DA202544436 - S168
Woden Village
Response to Significant Development Stage 1 Information Package

1.1 Table 1: Response to 1A Entity Advice

Image 6

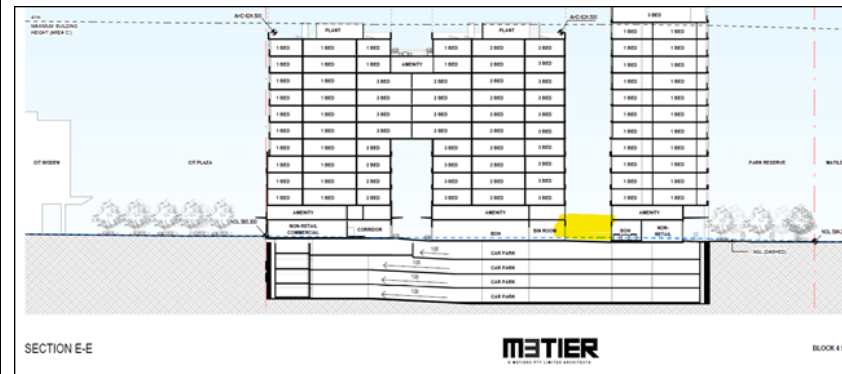
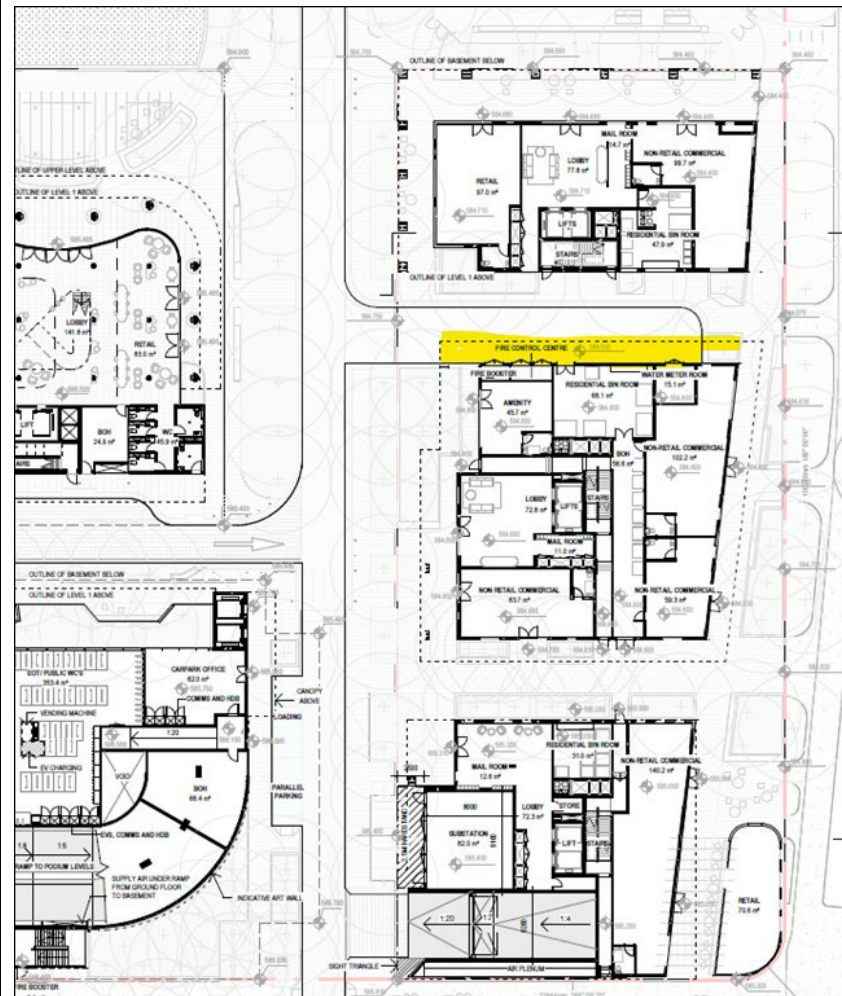
38. Vertical clearance for residential collection of 6.8m is required in the Service Laneway. Although Section E shows no obstructions on level 1 (Image 6), the ground floor plan shows an encroaching canopy (Image 7). Verification is required to confirm that 6.8m is provided in the laneway for waste collection.

The ground floor canopy has been removed to ensure there are no obstructions to waste collection.

Figure 1: Drawing DA9701 Public Notification Level 1 floor plan

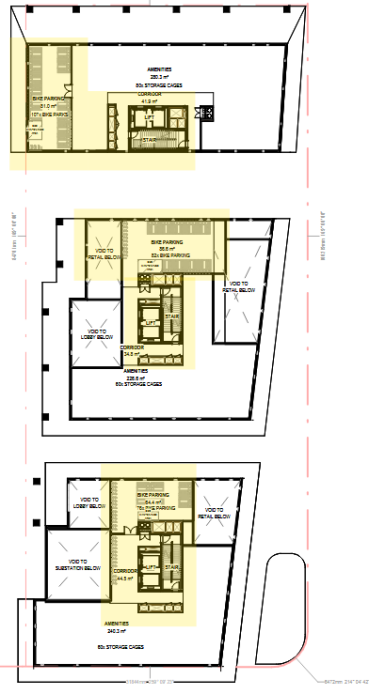
The plans for the residential buildings fronting Callum St do not appear to show access to and location of bicycle parking. Pedal Power ACT asks that the proponent provide plans showing access and location of bicycle parking in the residential buildings. We have concerns with other aspects of the development.

Residential bicycle parking is provided within the residential buildings and distributed across the site as part of the overall bicycle parking strategy. Apart from bicycle storage, addition storage areas for each unit have been provided on the same level. These facilities are intended to be accessed and used by residents of the respective buildings and will be managed through the building access control system and future strata management arrangements. The residential bicycle parking is located on Level 1 within the residential buildings. Refer to Drawing DA9701 Public Notification Level 1 floor plan.

Figure 2 : Drawing DA 9700, Ground Floor Plan

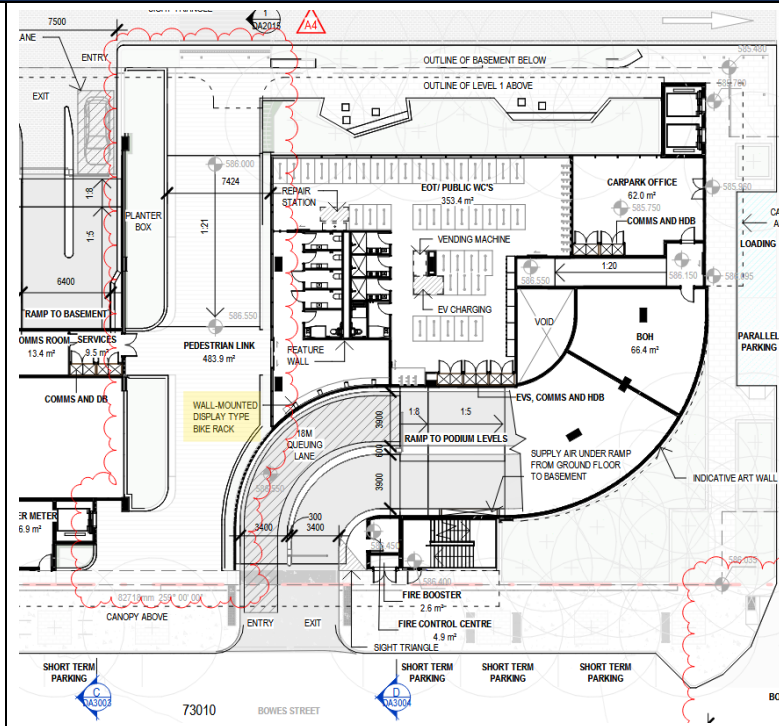
Neither Documents PARKING-202544436-02 nor LSCAPE-202544436-G-02 show the location of short stay bicycle parking rails. Pedal Power ACT asks that the proponent be required to provide that detail.

Additionally wall mounted bike racks have been provided within the end-of-trip facilities. Refer to Drawing DA 9700, Ground Floor Plan for further details.

Figure 5: Sketch Ground Floor Plan

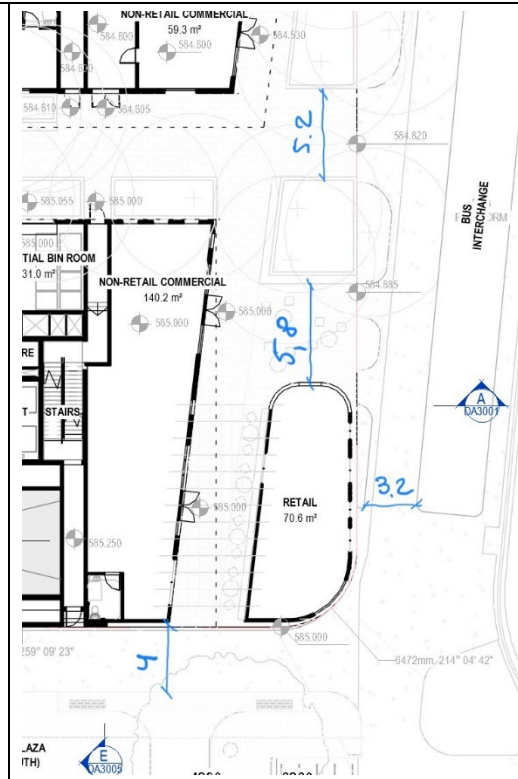
The proposed space between the buildings and the interchange platforms is very narrow considering the number of people likely to go to and from the bus platforms. When strollers, wheelchairs, scooters and bicycles are added to the mix it will be very congested. When human behaviour is considered (e.g. people rushing to catch a bus or running late for a CIT class), Pedal Power suggests the area will be unsafe.

- the proponent be required to increase the setback of the three buildings
- the proposed small retail structure, pergola and outdoor dining area not be approved
- the landscaping between the buildings and the interchange platforms be narrowed
- the proponent use small landscaping species for perimeter planting that, when fully grown, will not produce tree root intrusion and pavement tripping hazards.

The proposed design establishes multiple pedestrian routes across the site, each providing clear movement corridors exceeding 3m in width. These routes are complemented by wider east-west connections that support movement between the transport interchange, internal public spaces and surrounding streets. This network of paths distributes pedestrian movement across the site rather than concentrating it within a single corridor, reducing potential congestion and improving overall permeability.
